Safety Recall Notice

Subject:
Transtech Wheel Well Opening

Models:
Transtech (200,220 & 240 lengths)

10V - 370

INSTRUCTIONS FOR ENLARGING WHEEL WELL CUT-OUTS ON TRANSTECHS

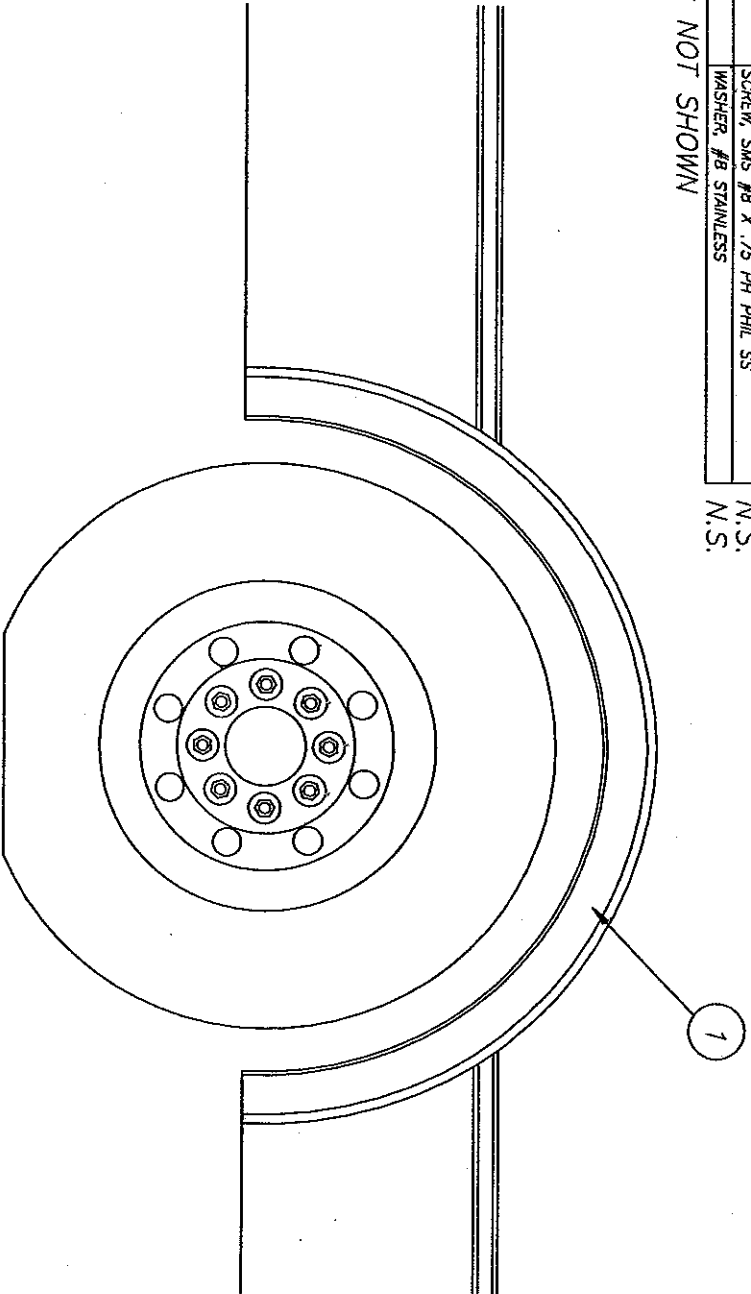
CONCERN: The potential exists for the fasteners that secure the wheel well rubber molding to penetrate or puncture the outside tire sidewall causing the tire to fail.

PURPOSE: Verify that opening size of the wheel matches the template to provide assurance there is proper clearance between the tire and wheel well rubber molding attachment fasteners.

SOLUTION: Enlarge the wheel well opening if necessary to a predetermined size by using a template to verify that the proper clearance will be attained.

- 1) REMOVE EXISTING RUBBER MOULDING FROM WHEEL WELL.
- 2) LOOSEN ALUMINUM TRIM ON BOTH SIDES OF WHEEL WELL.
- 3) ALIGN BOTTOM OF ENC SUPPLIED PAPER PATTERN WITH BOTTOM OF BUS SKIRT AND TAPE IN PLACE. TRACE AROUND PATTERN AND THEN REMOVE. PATTERN IS TO BE USED AGAIN ON THE OTHER SIDE OF THE BUS, SO TAKE CARE WHEN REMOVING THE PATTERN. CUT OUT ALONG TRACED LINE.
- 4) CUT NEW MOULDING TO NEEDED LENGTH AND ATTACH OVER WHEEL WELL CUT OUT USING NEW HARDWARE.
- 5) TRIM ALUMINUM MOULDING AS NEEDED AND RE ATTACH.
- 6) REPEAT SAME PROCEDURE ON OPPOSITE SIDE OF THE BUS.
